**ALERT SERVICE BULLETIN
REVISION NOTICE**

**SUBJECT: REVISION "A" TO ALERT SERVICE BULLETIN 427-06-15:
VERTICAL FIN TO TAIL ROTOR GEARBOX SUPPORT ATTACHMENT
HARDWARE REPLACEMENT OF.**

NO. 427- 06-15

MODEL AFFECTED: 427

Figure 1

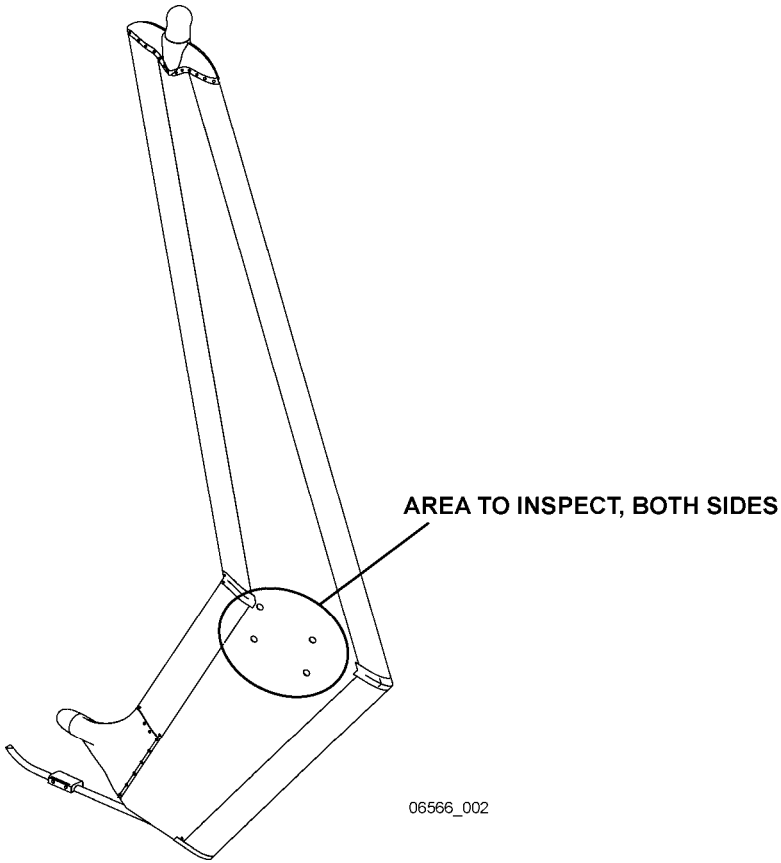
1. Remove vertical fin. Refer to BHT-427-MM chapter 53-00-00 paragraph 53-49. Discard all hardware.
2. Visually inspect inboard and outboard surfaces of the vertical fin for cracks, elongated bolt holes, fretting, distortion, and corrosion paying special attention to the area where it contacts the tail rotor gearbox support. Refer to Figure 1 for inspection area. If any damage is detected, contact Product Support Engineering.

Figure 2

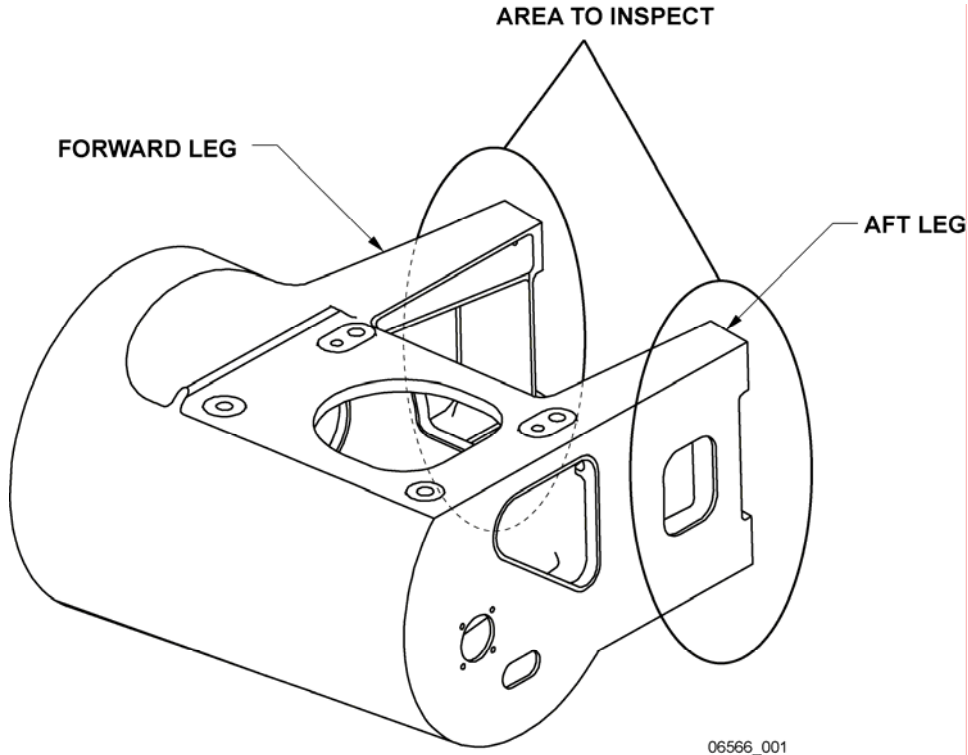
3. Visually inspect all four (4) attachment legs of the tail rotor gearbox support for cracks, fretting, bolt holes damage, threads marks, elongation and corrosion. Refer to Figure 2 for details. If any damage is detected, contact Product Support Engineering.
